PLANNING & ZONING COMMISSION MEETING

**Tuesday, April 01, 2025
7:00 PM**

Re: Sierra Vista West Section 11 Preliminary Plat
Letter of Recommendation to Approve
COIC Project No. 5860
Adico, LLC Project No. 710-25-002-005

Re: Alloy Road Street Dedication Phase 1 – Preliminary Plat
Letter of Recommendation to Approve
COIC Project No. 5867
Adico, LLC Project No. 710-25-002-006

SIERRA VISTA WEST SEC 11

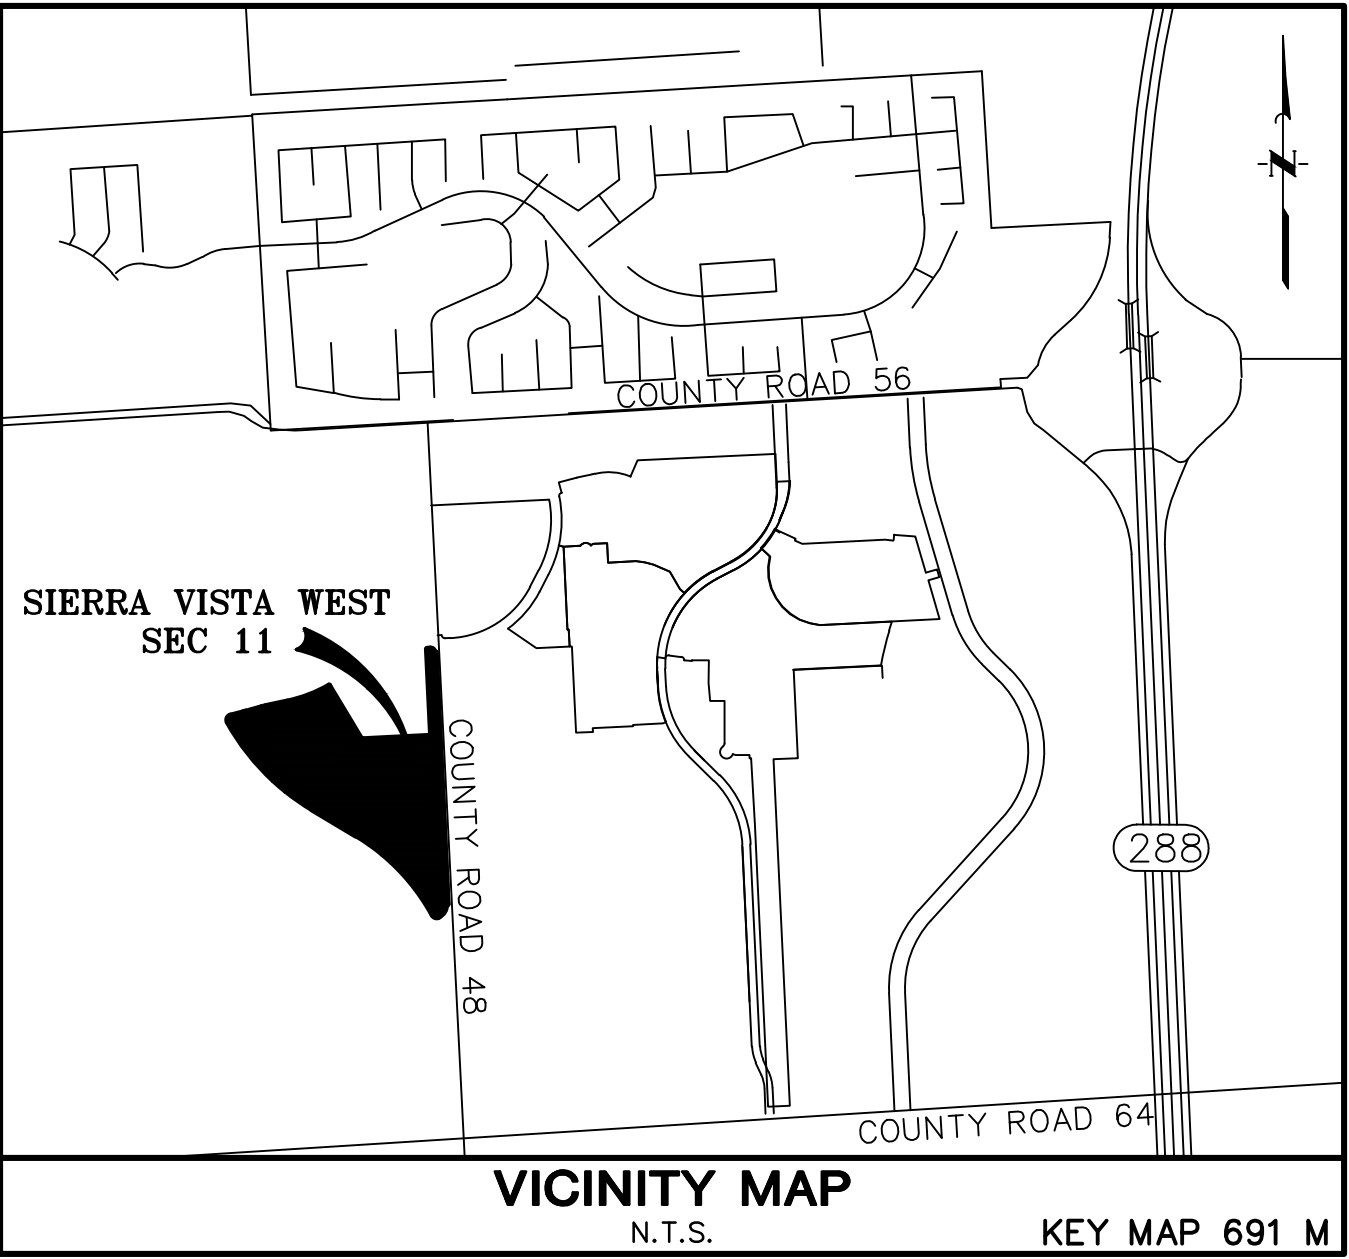
On behalf of the City of Iowa Colony, Adico, LLC has reviewed the second submittal of Sierra Vista West Section 11 Preliminary Plat, received on or about March 20, 2025. The review of the plat is based on the City of Iowa Colony Subdivision Ordinance dated August 2002, and as amended.

Based on our review, we have no objection to the plat as resubmitted on March 20, 2025. Please provide ten (10) prints of the plat to Kayleen Rosser, City Secretary, by no later than March 25, 2025, for consideration at the April 1, 2025, Planning and Zoning meeting.

ALLOY ROAD STREET DEDICATION PHASE 1

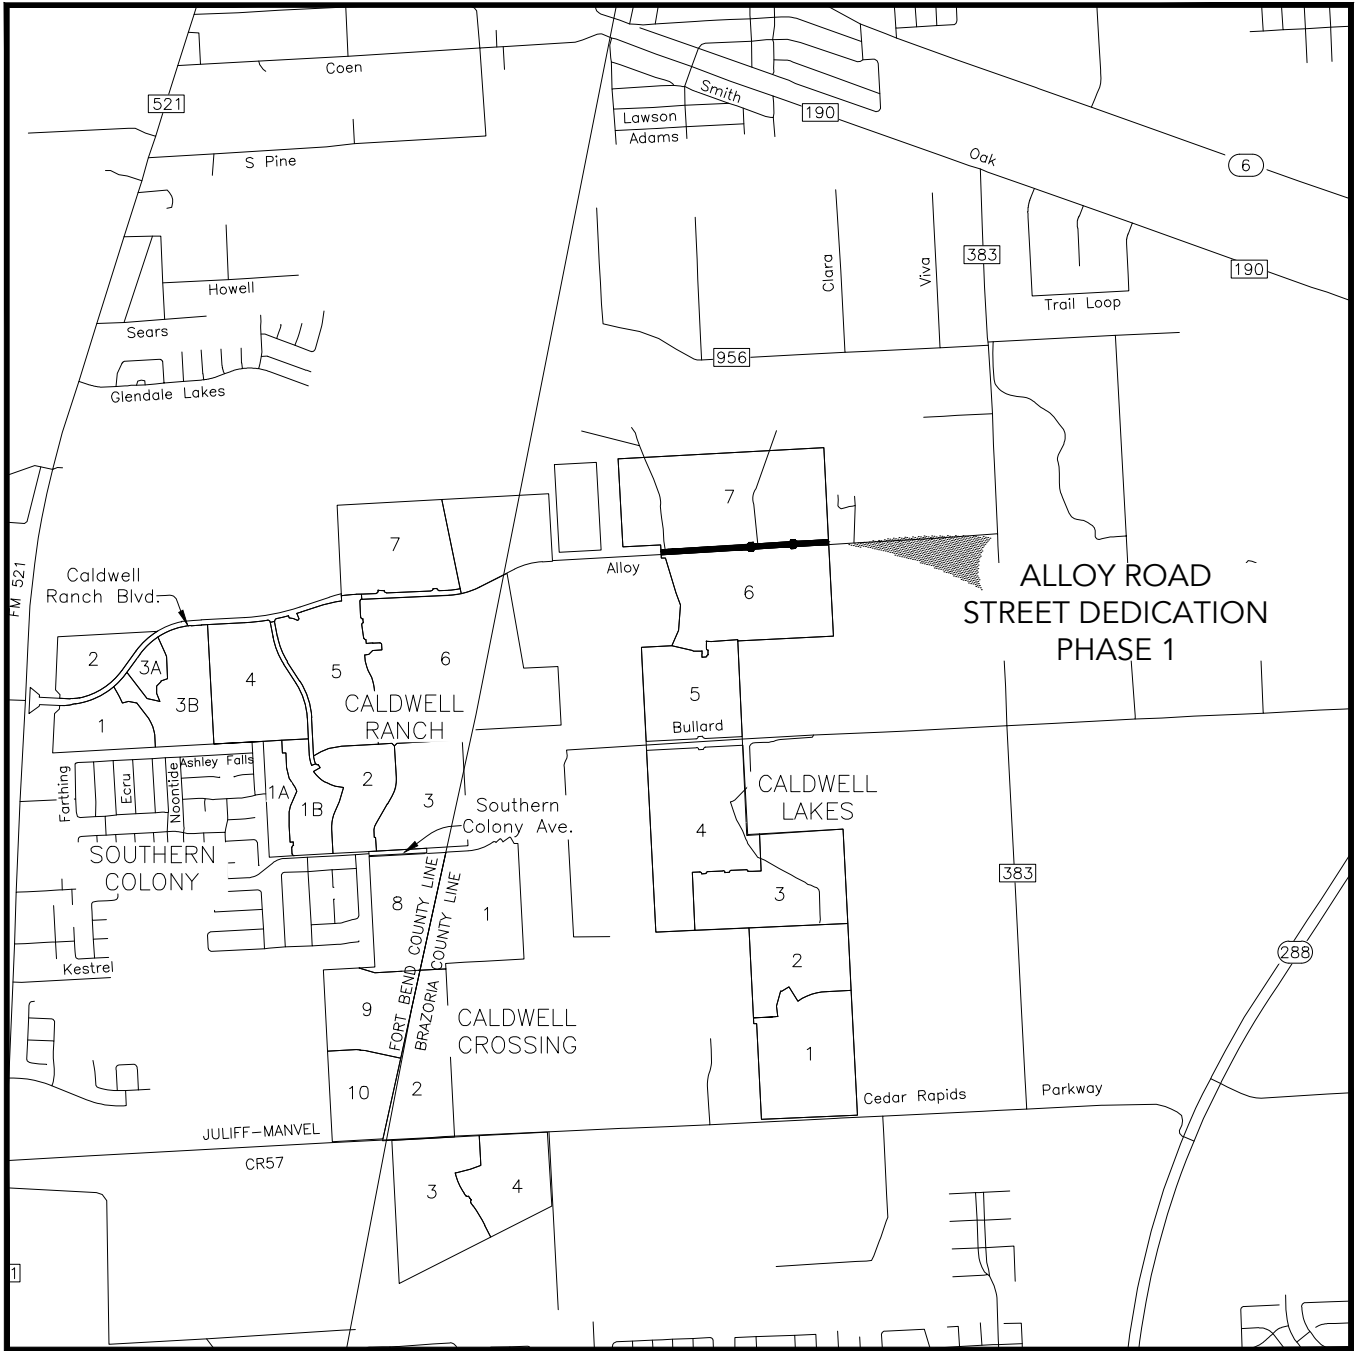
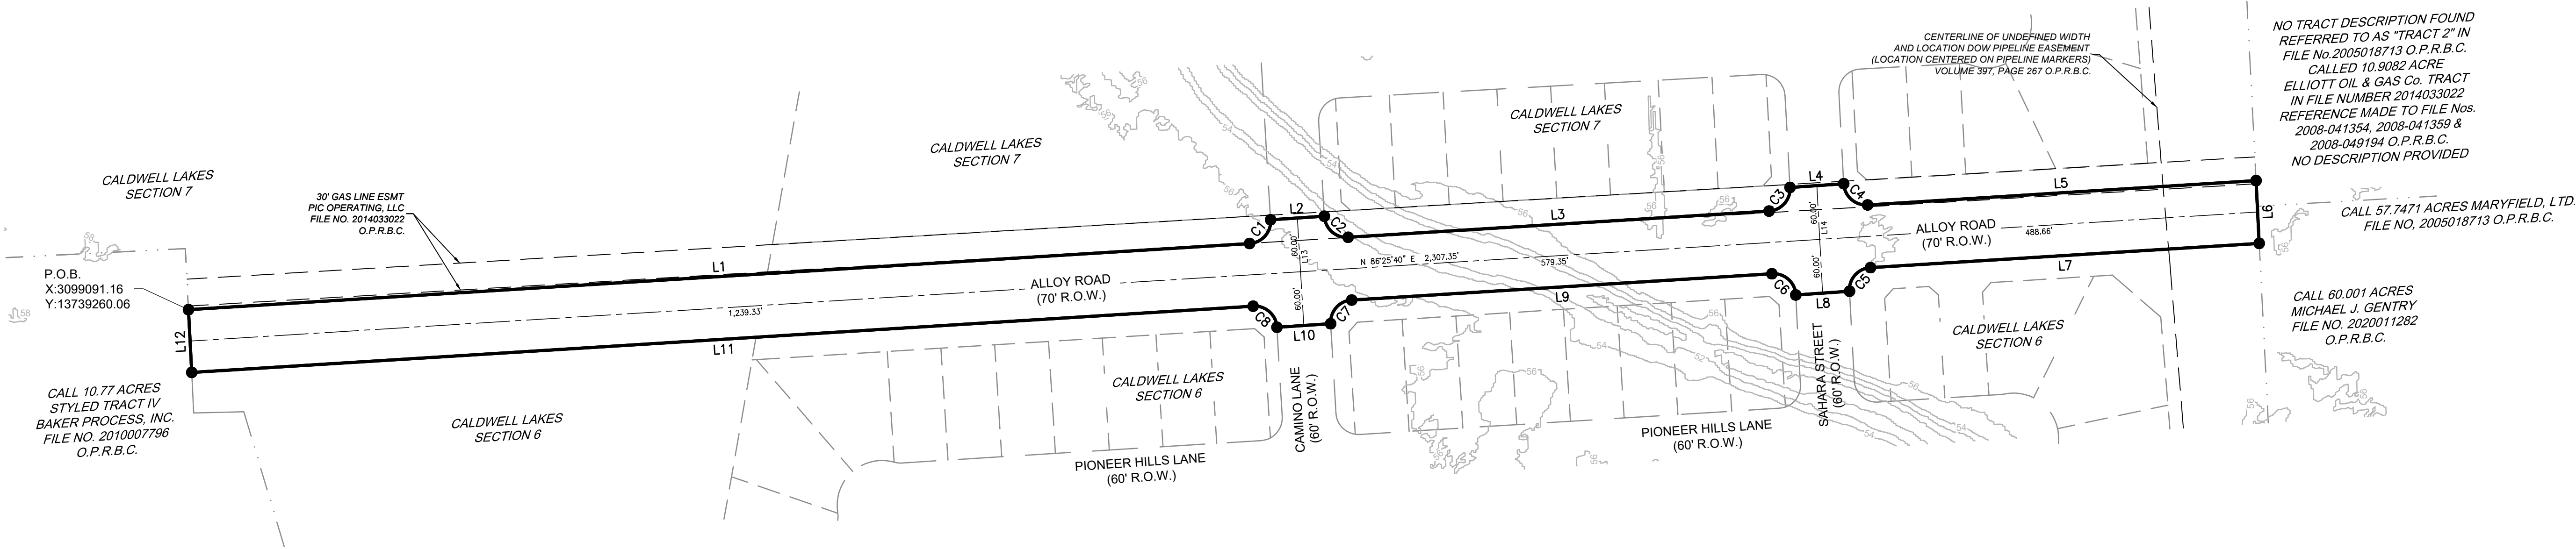
On behalf of the City of Iowa Colony, Adico, LLC has reviewed the initial submittal of Allow Road Street Dedication Phase 1 Preliminary Plat, received on or about March 4, 2025. The review of the plat is based on the City of Iowa Colony Subdivision Ordinance dated August 2002, and as amended.

Based on our review, we have no objection to the preliminary plat as submitted on March 4, 2025. Please provide ten (10) prints of the plat to Kayleen Rosser, City Secretary, by no later than March 25, 2025, for consideration at the April 1, 2025, Planning and Zoning meeting.

PRELIMINARY PLAT OF STERLING LAKES AT IOWA COLONY SEC 4 PARTIAL REPLAT NO. 1

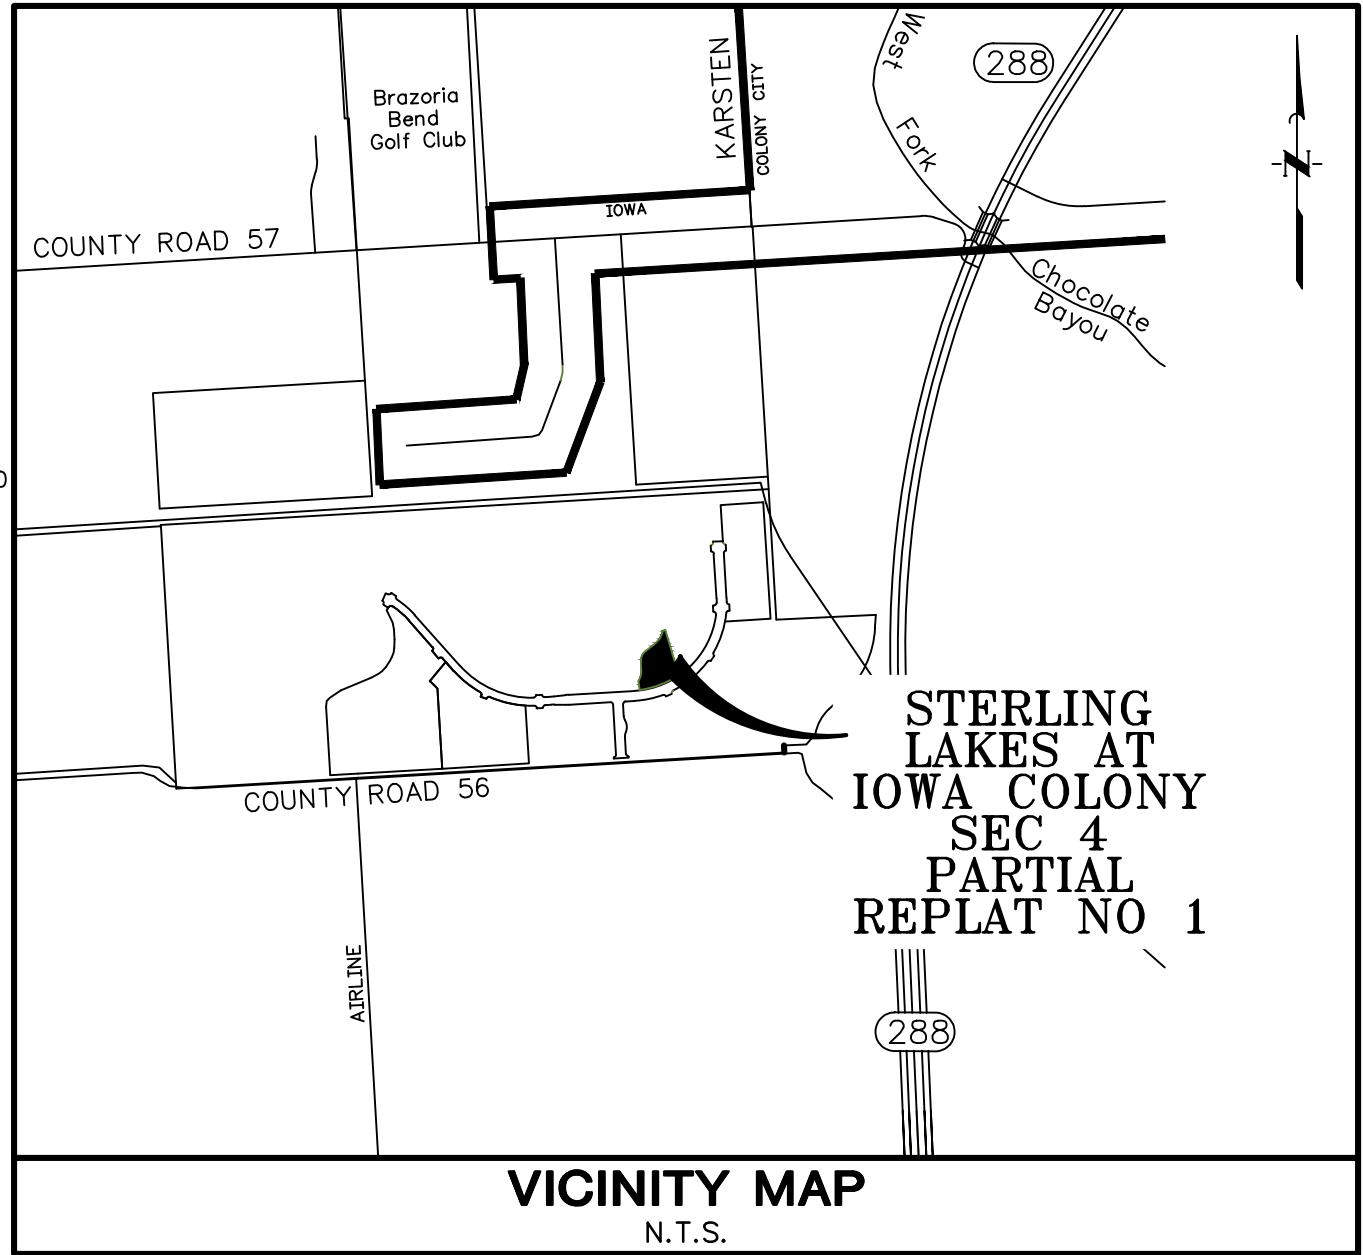
On behalf of the City of Iowa Colony, Adico, LLC has reviewed the second submittal of Sterling Lakes at Iowa Colony Section 4 Partial Replat No. 1 - Preliminary Plat, received on or about March 20, 2025. The review of the plat is based on the City of Iowa Colony Subdivision Ordinance dated August 2002, and as amended.

Based on our review, we have no objection to the plat as resubmitted on March 20, 2025. Please provide ten (10) prints of the plat to Kayleen Rosser, City Secretary, by no later than March 25, 2025, for consideration at the April 1, 2025, Planning and Zoning meeting.

PRELIMINARY PLAT KARSTEN BOULEVARD NORTH PH IV & STERLING LAKES DRIVE STREET DEDICATION & COMMERCIAL RESERVES

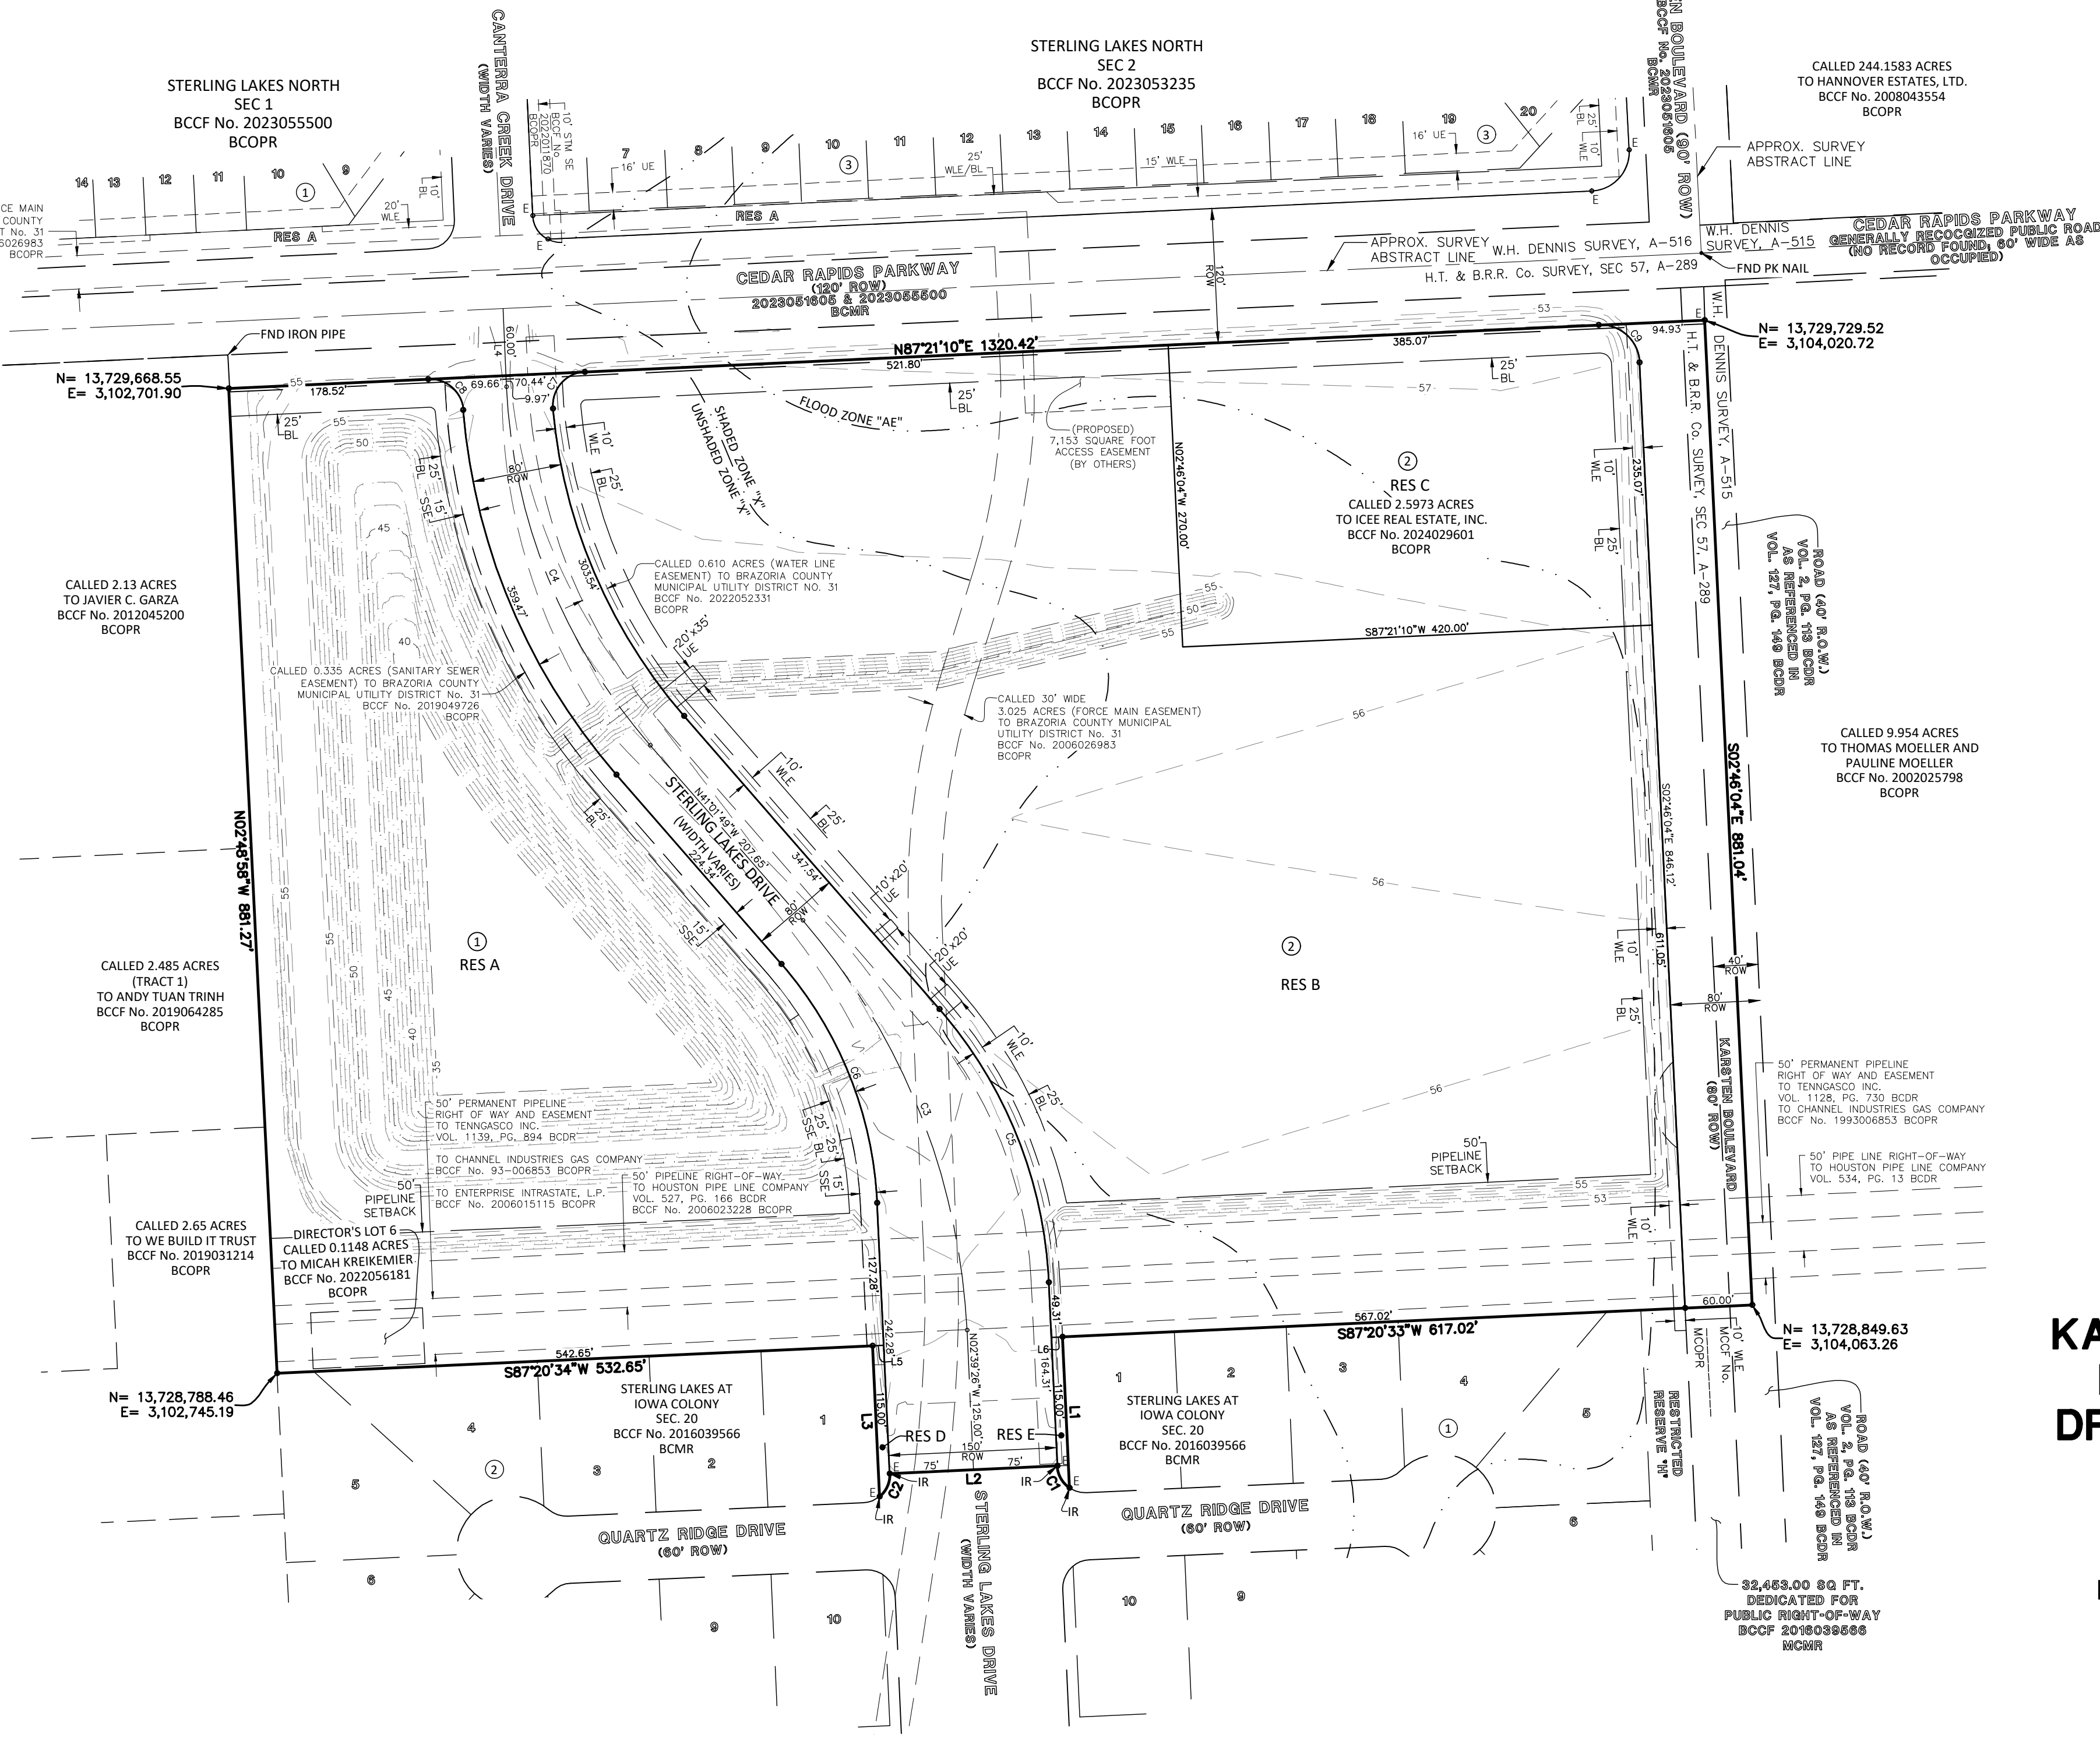
On behalf of the City of Iowa Colony, Adico, LLC has reviewed the second submittal for Karsten Boulevard North Phase IV & Sterling Lakes Drive Street Dedication & Commercial Reserves Preliminary Plat, received on or about March 25, 2025. The review of the plat is based on the City of Iowa Colony Subdivision Ordinance dated August 2002, and as amended.

Based on our review, we have no objection to the plat as resubmitted on March 25, 2025. Please provide ten (10) prints of the plat to Kayleen Rosser, City Secretary, by no later than March 25, 2025, for consideration at the April 1, 2025, Planning and Zoning meeting.
